**SAN ANTONIO WATER SYSTEM**  
**Interdepartment Correspondence Sheet**

**To:** Zoning Commission Members  
**From:** Kirk M. Nixon, Manager, Resource Protection Division, San Antonio Water System  
**Copies To:** Scott R. Halty, Director, Resource Protection & Compliance Department, Mike Barr, Resource Protection Specialist II, Aquifer Protection & Evaluation Section, File  
**Subject:** Zoning Case Z2007090 (The Rim Master Plan)

**Date:** April 25, 2007

**Zoning Case No. Z2007090 Figure 3**

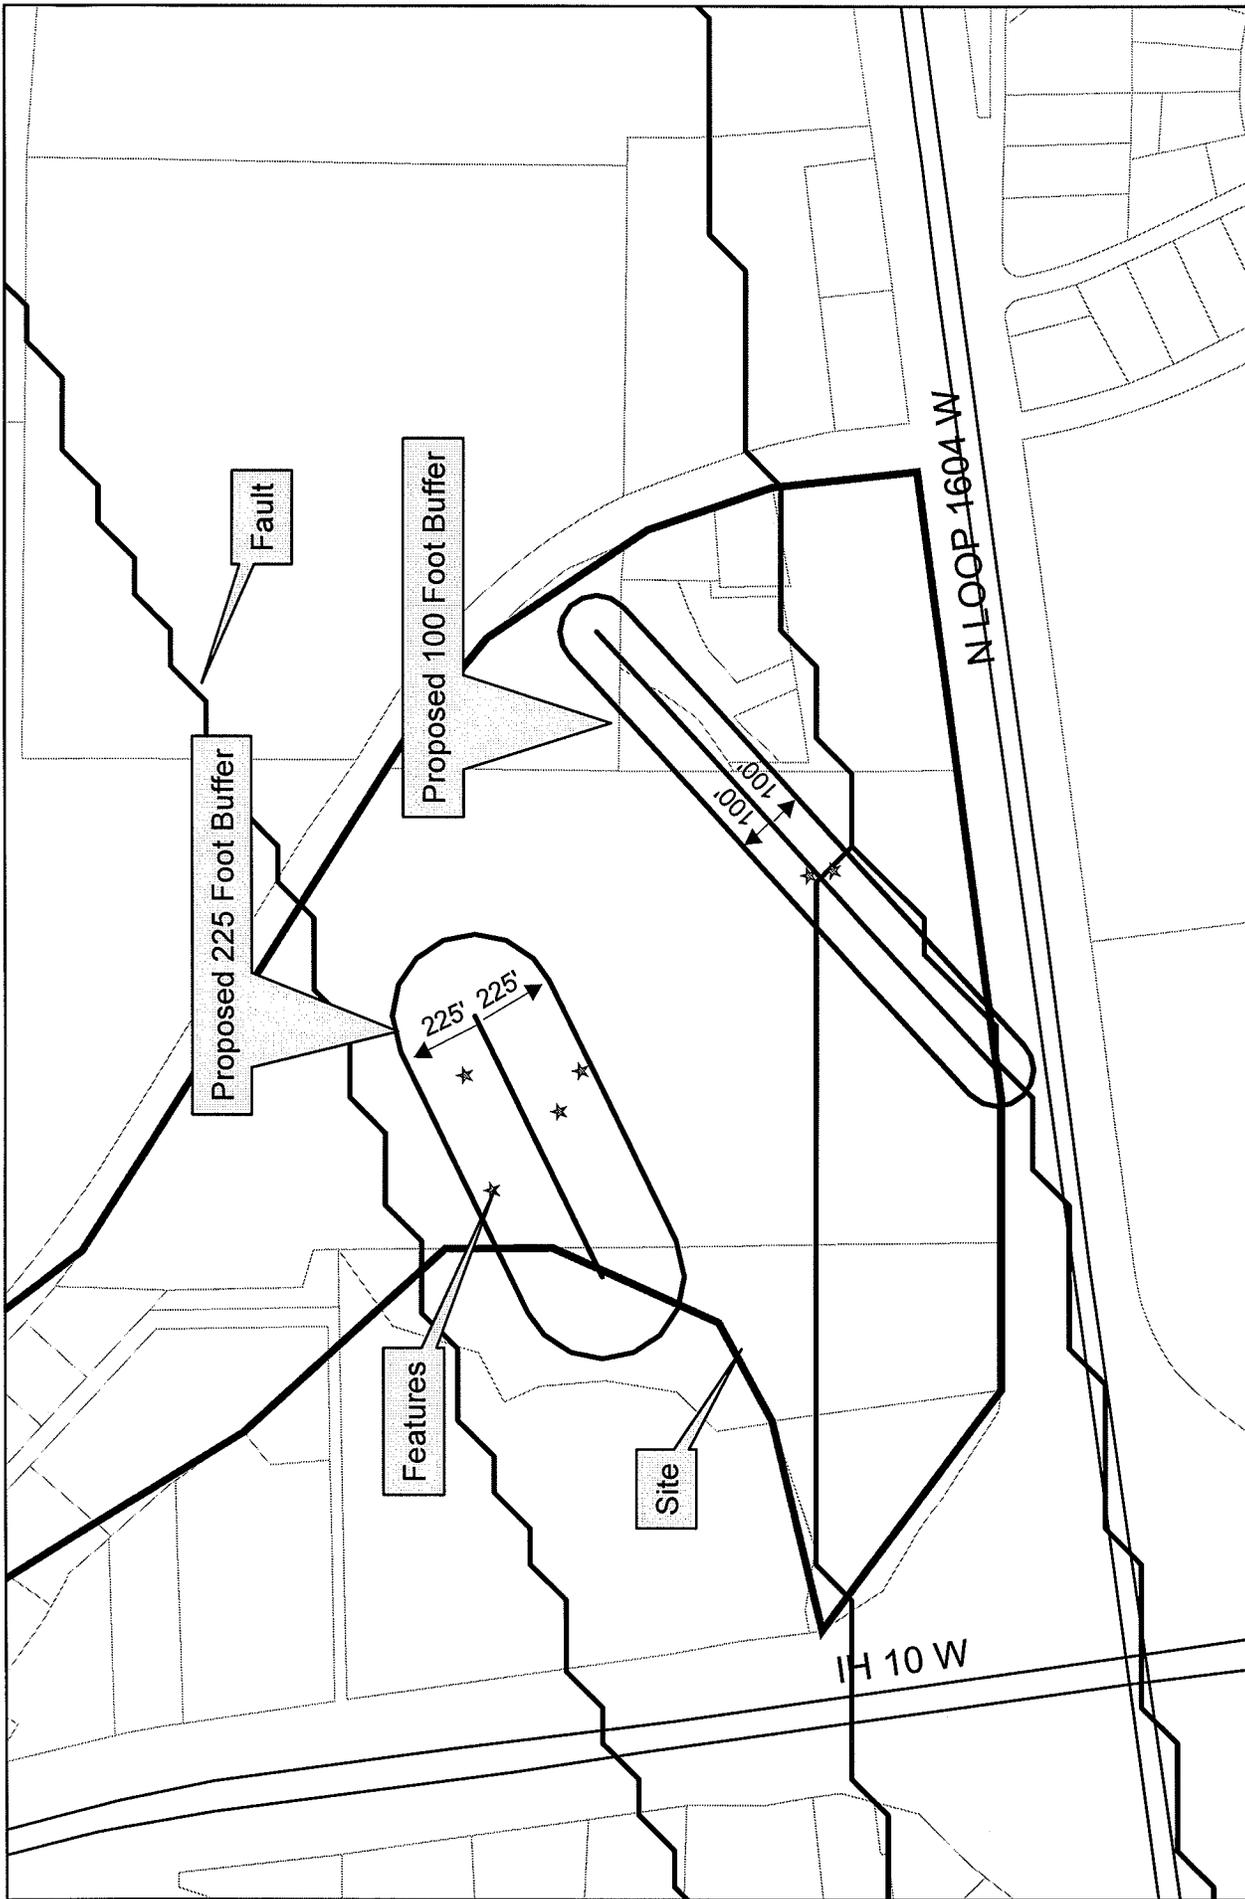
2. A buffer area shall be provided as delineated in figure 3 which shall include:
  - a. An area trending NE-SW that is located in the north-central portion of the C (III) location.

- b. A small tributary to Leon Creek trending NE-SW that is located in the southern portion of the C (III) location.
3. The abandoned septic systems, along with any additional septic system that may be located on the site must be properly abandoned according to City Code Chapter 34 Article V Division 2 Section 446.
